Groundwater Application Review Summary Form

Application # G- 19290

PUBLIC INTEREST REVIEW FOR GROUNDWATER APPLICATIONS

TO: Water Rights Section Date 6/26/2023
 FROM: Groundwater Section Stacey Garrison/Travis Brown
 Reviewer's Name
 SUBJECT: Application G- 19290 Supersedes review of _____
 Date of Review(s) _____

Water-Level Measurements in Nearby Wells

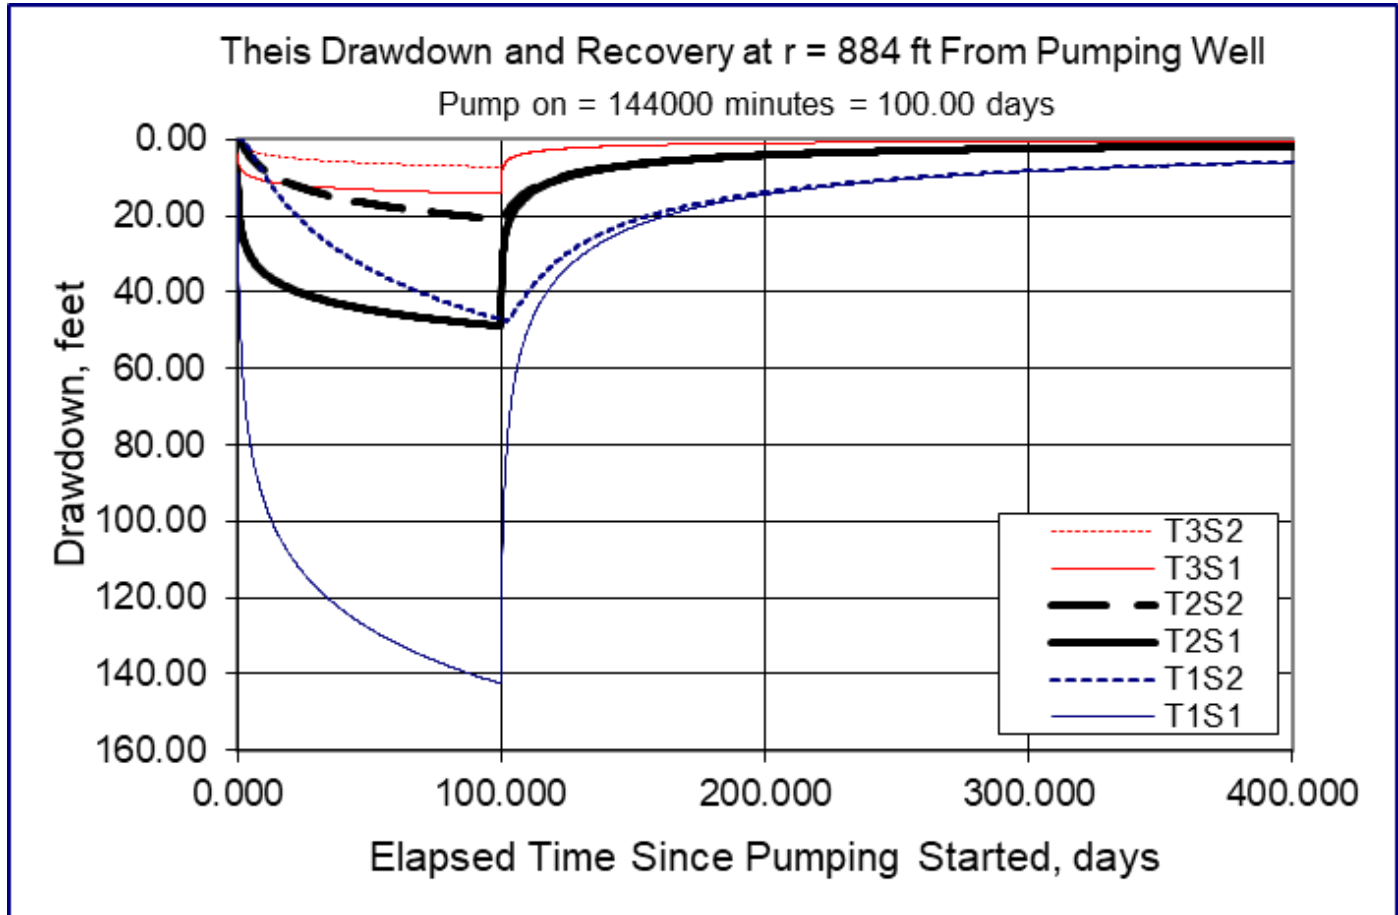
- B3. **Groundwater availability remarks:** The proposed POA/POU are on Missoula Flood deposits, a Quaternary sequence of bedded silts, sands, and clays up to 80 feet thick in this area (Gannet and Caldwell 1998, O'Connor et al 2001). Based on the proposed depth of the POA, it will likely utilize the Willamette aquifer that underlies the Missoula Flood deposits (Gannet and Caldwell 1998, O'Connor et al 2001). These fluvial terrace deposits include a variety of grain sizes and different degrees of consolidation, resulting in a wide range of hydraulic conductivity values (Woodward et al 1998). Department-located wells within 1 mile of the POAs and utilizing the Quaternary Late Tertiary Sediment (QLTS) aquifer system (CLAC 171, CLAC 1999, CLAC 2000, CLAC 2028, CLAC 2356, CLAC 2378, CLAC 3180, CLAC 5338, CLAC 12673, CLAC 12674, CLAC 12675, CLAC 12676, CLAC 12696, CLAC 12699, CLAC 12701, CLAC 12713, CLAC 50080, CLAC 51287, CLAC 55788, CLAC 62806, CLAC 64841, CLAC 65758, CLAC 66381, CLAC 70824, CLAC 71344, CLAC 73974, and CLAC 76203) identify multiple water-bearing zones, WBZs, ranging from -164 to 136 ft msl, with thickness varying from 3 to 248 ft, and described in well logs as clay, claystone, sand, sandstone, silt, and gravel. The SWLs range from 96 to 173 ft msl and are above the elevation of the top of the respective WBZs, indicating confined conditions. A review of statistics for nearby well records was completed and compared with the proposed rate of 0.946 cfs (424.6 gpm) for this application (see Well Statistics). Median reported well yield is 40 gpm, and the maximum reported yield is 1,000 gpm. The proposed rate for this application is 1,062% of the median and 42% of the maximum reported yield. For the wells within 1 mile and discussed above the maximum yield is 1,000 gpm, the minimum is 25 gpm, and the median is 80 gpm. The proposed rate of use of 0.946 cfs (424.6 gpm) is likely within the capacity of the groundwater resource. Water levels appear to be stable (see Water Level Measurements in Nearby Wells). For the 25 QLTS observation wells within 2 miles of the POAs, 19 show negligible change for the period of record. The maximum declines are approximately 10 ft in CLAC 12612, CLAC 19195, CLAC 2009, and CLAC 2027. There have also been gains of about 20 ft in CLAC 20346 and CLAC 55112. There is not a preponderance of evidence to indicate the groundwater resource is over-appropriated.

Theis Drawdown Analysis**POA 1**

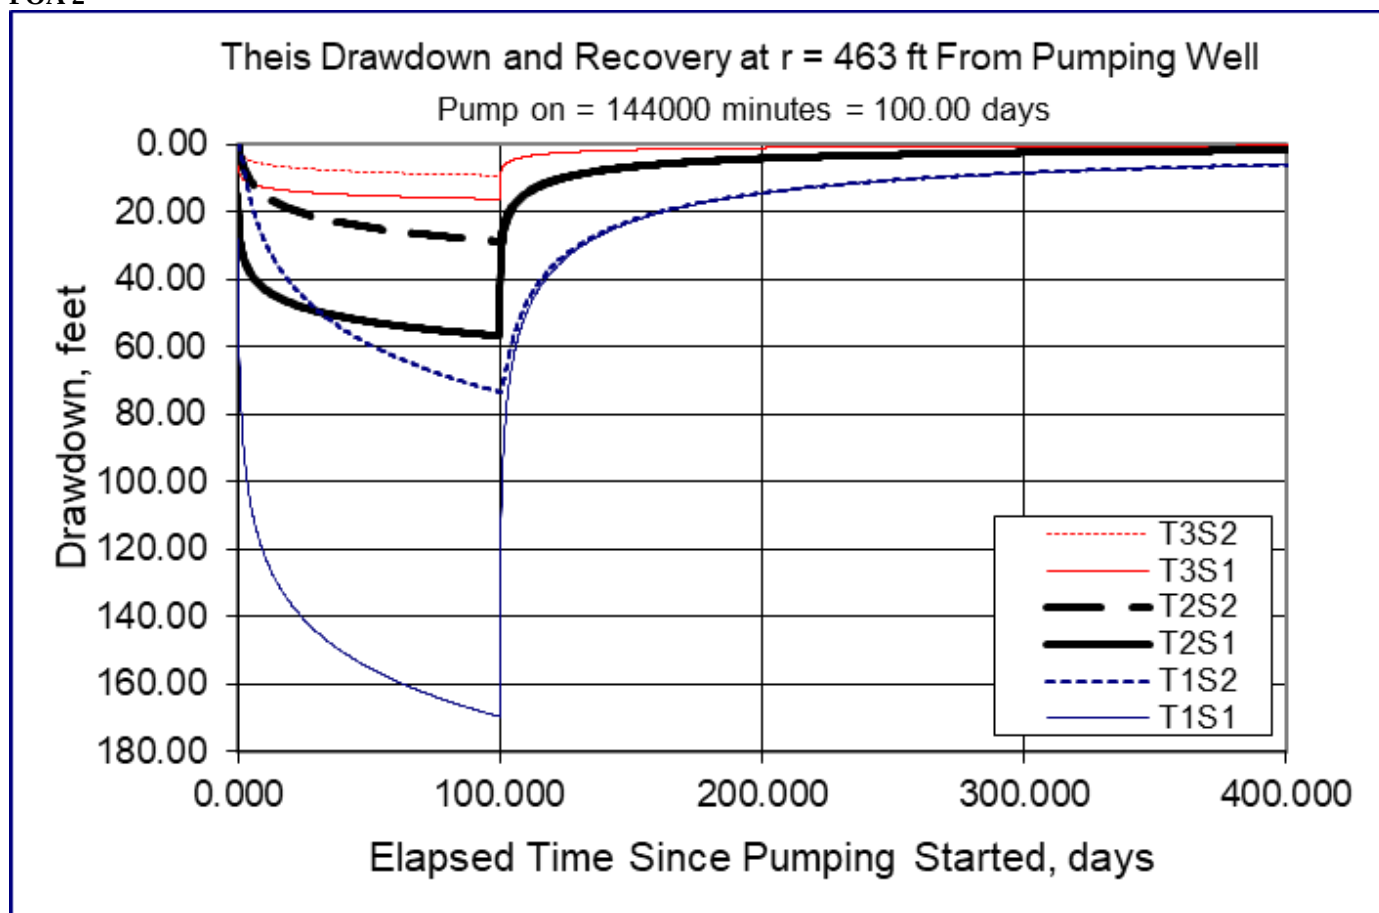
The nearest groundwater user to POA 1 is the exempt domestic well serving tax lot 1102 at 29961 Whiskey Hill Road, 884 ft north of the POA at an elevation of ~182 ft msl. A well log could not be associated with this tax lot or address but is likely given the identification of well logs associated with other domestic tax lots in this area (CLAC 66381, CLAC 12673, CLAC 63180, CLAC 12675, CLAC 12675). It is likely the proposed use would cause some degree of well-to-well interference with the domestic well for tax lot 1102. To assess the degree of drawdown, a Theis drawdown analysis was conducted for the proposed use (see attached Theis Drawdown Analysis-POA 1). Results indicate that the proposed use is not likely to cause

well-to-well interference with the well for tax lot 1102 that exceeds the threshold under the standard condition for alluvial aquifers in the Willamette Basin.
